Product Change Notification
Software Release Notice

MultiConnect[®] rCell 100 Series Cellular Routers

mPower[™] Edge Intelligence mPower 5.2 Firmware Available

PCN 06022020-MTR-001

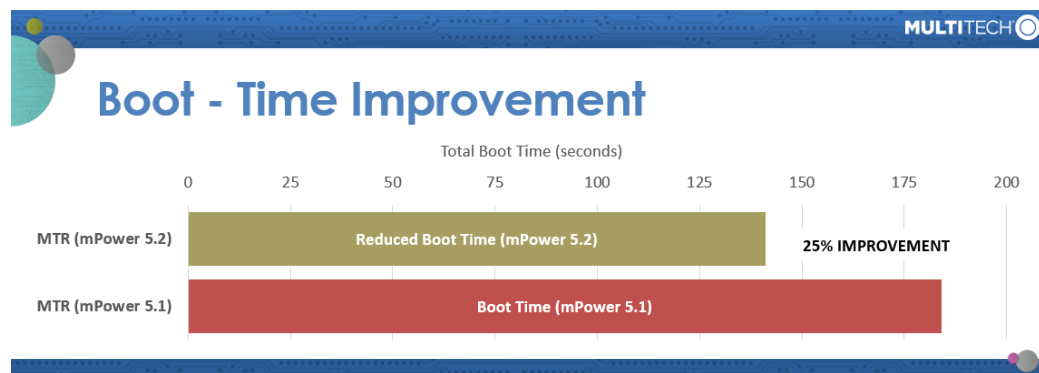
1. Reduced Boot Time Previous versions of mPower resulted in longer boot times. mPower 5.2 includes new features and optimization that decrease the device boot time up to 25% [GP-256, GP-360, GP-362, GP-363, GP-364]

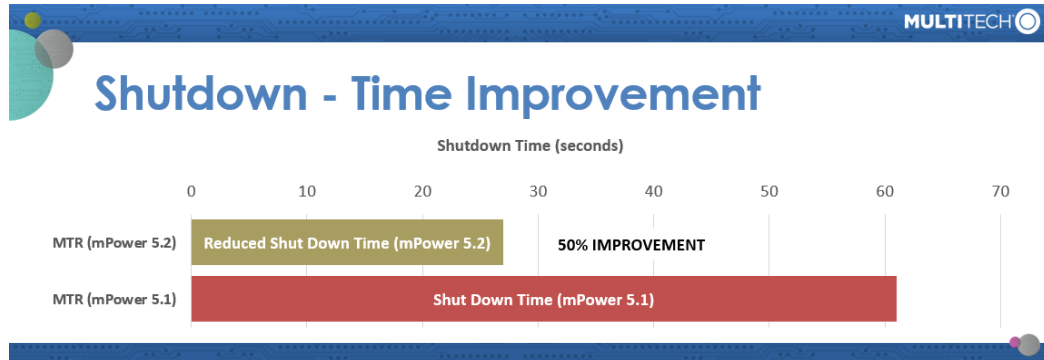
2. **Shutdown Time Optimization:** When restarting a device, the total time to reboot also includes shutdown time. Previous versions of mPower resulted in longer shutdown times. mPower 5.2 has been updated to reduce shutdown time. MTR mPower shutdown time has been shortened by 50%.

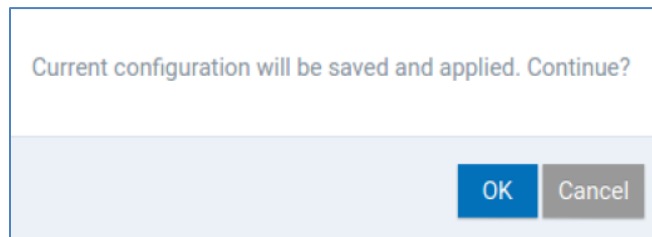
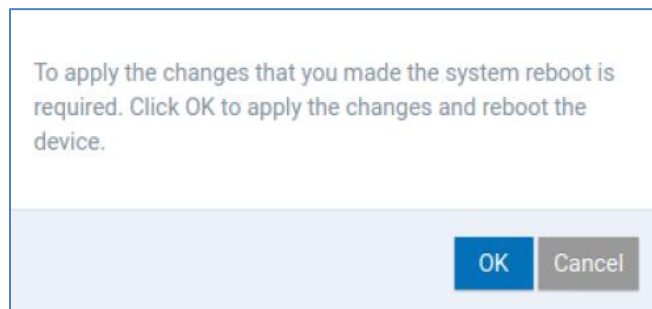
3. **Save and Apply Configuration Settings without Restarting:** Previous versions of mPower required a device reboot for most system configuration settings. mPower 5.2 has been updated to save and apply many configuration settings without the need to restart. In these cases, the user will be presented a “Save and Apply” button after making configuration settings. If “Cancel” is selected, changes are not saved. [GP-339]

A limited number of system configuration setting changes will still require the device to be restarted. In these cases, the user will be presented with a “Save and Reboot” button after making configuration settings. If “Cancel” is selected, changes are not saved.
